- A. LaSalle Estates Subdivision - 2000 N. Chestnut Ave. - PC#19-009
Preliminary and Final Plat of Subdivision, Setback Variation

RE: THE LaSALLE ESTATES SUBDIVISION - 2000 N. CHESTNUT AVENUE - PC# 19-009
PLAT OF SUBDIVISION, VARIATION

File Number: PC 19-009
Project Title: LaSalle Estates Subdivision
Address: 2000 N. Chestnut Avenue
PIN: 03-18-401-085

SITE DEVELOPMENT PLAN
SCALE: 1"=20'
DATE: 06/13/2019
DRAWING: D.D.D.

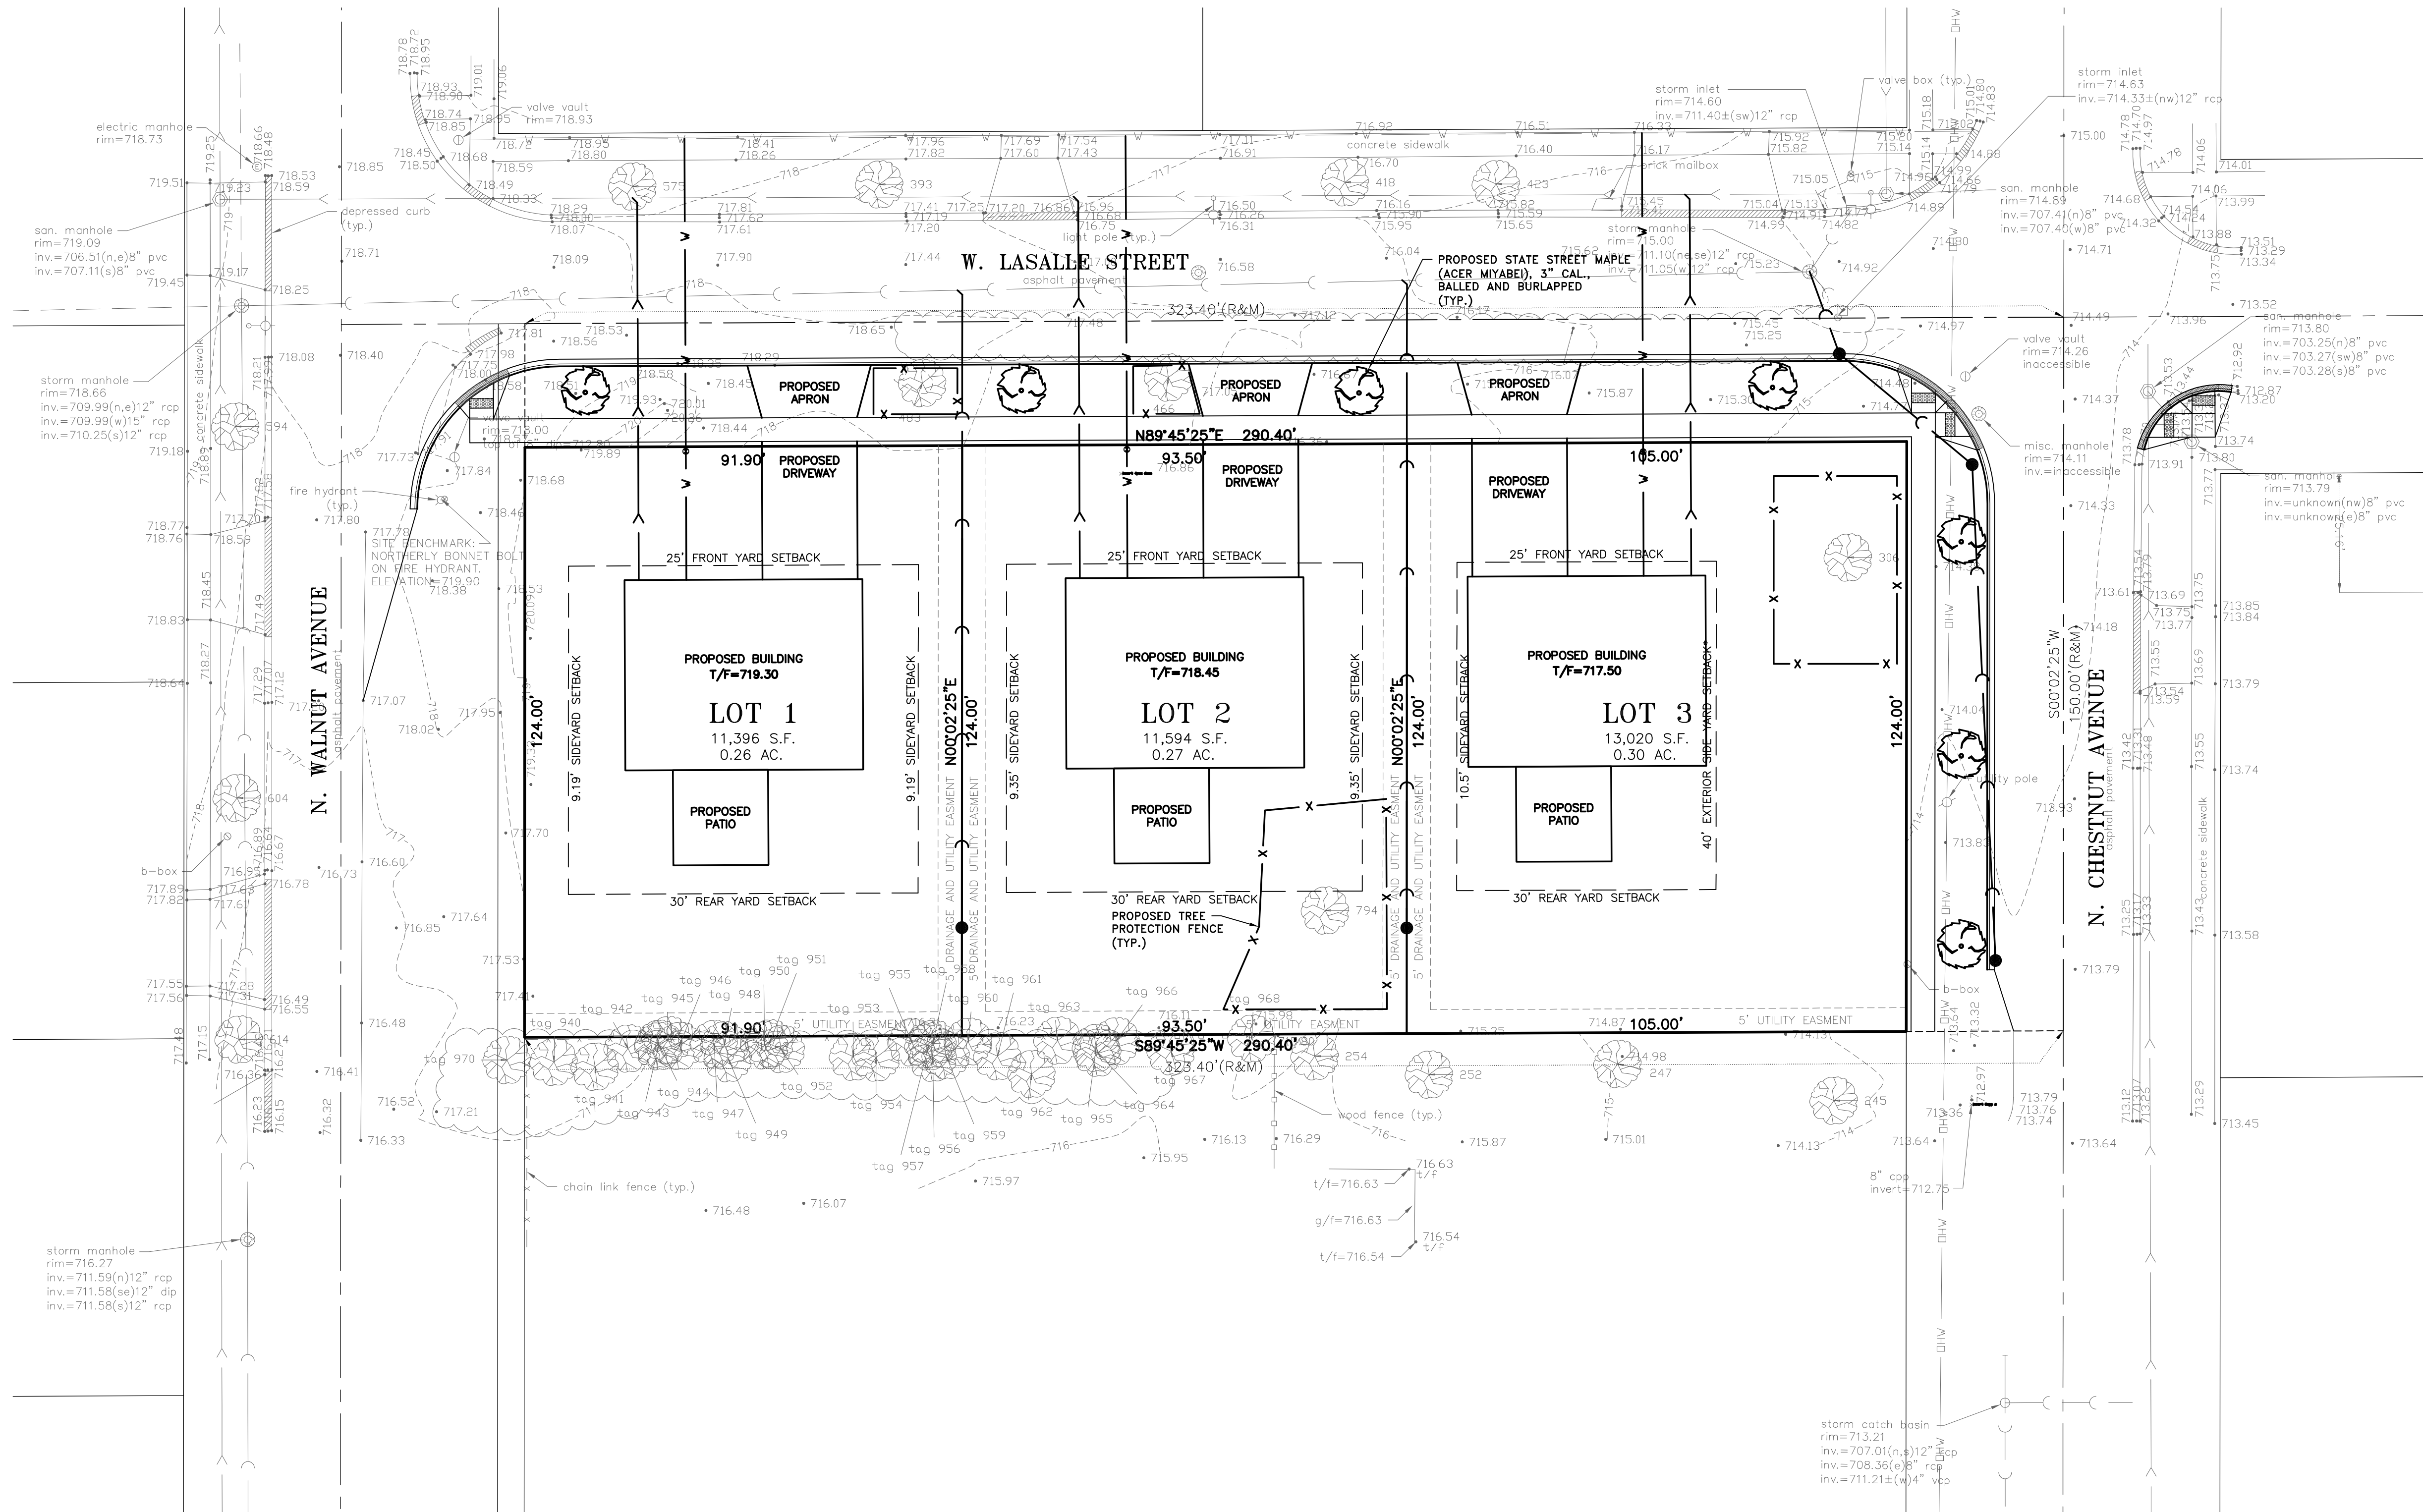
17. The proposed cross section for a local street shall consist of 2" N50 surface, 2 1/4" N50 surface, 5" N50 binder, and 4" CA-6. Verify the existing curb on the east side of Chestnut Ave and the north side of LaSalle St. If the existing curb is B-4.12, match existing curb. Revise the cross section accordingly.

18. The proposed ADA ramps shall be constructed to meet the Public Rights-of-Way Accessibility guidelines and IDOT standard detail 222-424001-11 Perpendicular Curb Ramps. New ramps should also be constructed at the SW and SE corners, providing an east/west pedestrian access route across Chestnut Ave.

- 1) New water services must be 1.5" to the meter and the meters will be 1". The plan sheet details a 1.25" water service, however the detail sheet calls for 1.5", reconcile this disparity.

18. ADA ramps follow IDOT guidelines. IDOT detail 222-424001-11 added to plans. New ramps for the southeast and southwest corners at Chestnut added to plan.

25. The response to comment #16 is noted. The Village is requesting that you modify the western side yard setback for Lot 1 from 9.19' to 20' as this yard will function more like an exterior side yard given the proximity to Walnut Avenue. Of note, staff is supportive of a variation to Lot 3 to reduce the western exterior side yard setback from 40' to 30'. Please adjust the plans if this reduction is desired for Lot 3. Of note, the setback for Lot 1 (and potentially Lot 3) will also need to be adjusted on the Engineering Plan sheets 3, 4, and 5, as well as on the Preliminary Plat.
